Clarke County School District

SUBJECT: ADDENDUM NO.1- RFQ# 24-0401-B2, Electrical Services – WR Coile Modular Health Clinic

1 SITE PLAN - ELECTRICAL
E001 1" = 40'-0"

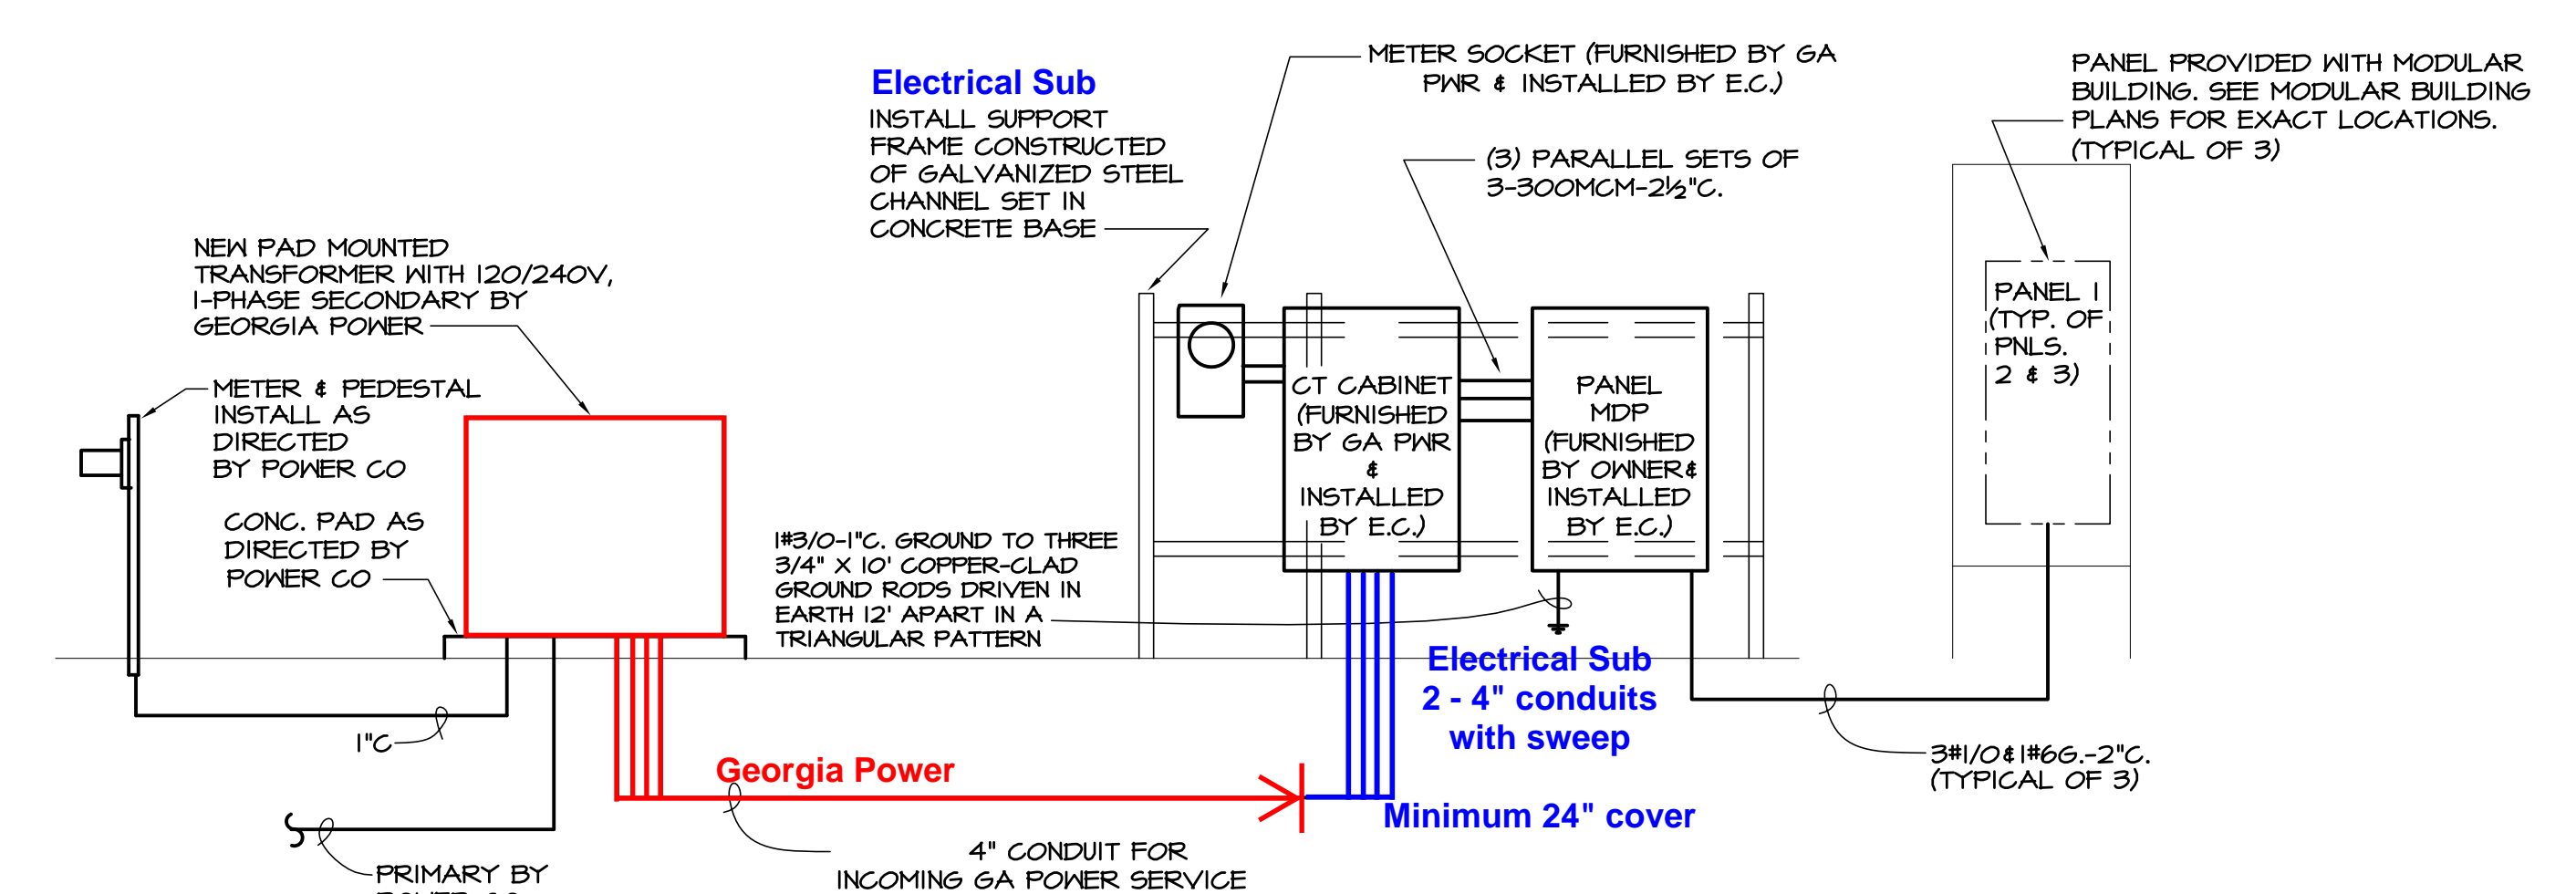
1. **Page 2 - Answers to questions:** Full list
2. **Page 3 - Exhibit #1:** Updated E001 sheet with Ga Power update and fiber conduit identified.
3. **Page 4-9 - Exhibit #2:** Fire Alarm Specs

Question	Answer
General	
The submission instructions note that an original and two (2) copies of the bid must be submitted in a sealed envelope to the Clark County School District SPLOST Office. Per Section II Instructions to Bidders, part D. Bid Form also notes documents can be submitted in an e-mail. If acceptable, please confirm bid is to be emailed to Troy Bassett at bassett@clarke.k12.ga.us	Email is acceptable.
RFQ No. 24-0401-B1 Plumbing	
Will CCSD be paying for sewer tap fees and new water meter fees?	CCSD to pay for sewer and water meter fees.
Will the plumbing contractor be responsible for seed/straw on that portion of the job or will that fall to the civil contractor?	Plumbing subcontractor to grade, seed and straw area disturbed by water and sewer line installation.
RFQ No. 24-0401-B2 - Electrical	
Can the transformer location be changed from the location shown on the plans? The plans show it farther away from the panels but closer to the far end of the building.	Transformer to be located per site plan E001. GA Power is boring the road and running the wire from the transformer to the CT cabinet.

Can we substitute 3" conduit under the road rather than the 4" shown? The rest of the project shows 3" conduit.	GA Power will install conduit and wire to the CT cabinet at the building. Vendor will be responsible to 2 - 4" conduits with sweep out of the CT Cabinet. See updated drawing.
The scope on Page 16 lists 1 - 2" conduit to the light pole at the street noted on the electrical plans for phone/wireless service. Is that the conduit listed as 4" on the plans?	It's a 2" conduit for fiber. See updated E001 sheet.
To what point is GA Power bringing their side? I remember at Cedar the drawings were not accurate as to what they we're going to provide.	GA Power will install conduit and wire to the CT cabinet at the building. Vendor will be responsible to 2 - 4" conduits with sweep out of the CT Cabinet. See updated drawing.
At what point is GA Power stopping their portion as their drawing & our scope are saying different things - GA Power's drawing is saying they are bringing conduit & power to our service panel, including the bore under the road or E001 drawing shows us providing a 4" conduit to the transformer pad (other side of road) & GA Power installing the wire in the provided conduit	GA Power will install conduit and wire to the CT cabinet at the building. Vendor will be responsible to 2 - 4" conduits with sweep out of the CT Cabinet. See updated drawing.

I do not see the location of the light pole we are to run the 2" communications conduit to? Can you tell me what drawing this is listed if I'm just missing it?	2 inch conduit to be run to edge of property line as shown per attached sketch.
Are we providing power to the fire alarm system as we have on past projects with CCSD handling the actual system installation as they have in the past OR should I include pricing for an entire fire alarm system installation done by our subcontractor?	Electrical subcontractor to provide Firelite fire alarm system for building, see attached spec.
RFQ No. 24-0401-B3 - Site Improvements	
Will the ramp require handrails? There is a typical example in the drawings showing handrail on the steps, but not clear on being required or placement on the ramp.	Ramp requires handrails.
Will the civil part be responsible for seed and straw over the entire project or just immediately around the new building? Will the electrical and plumbing portion be responsible for seed and straw on that portion of the job?	Each sub will be responsible for their portion of the job.
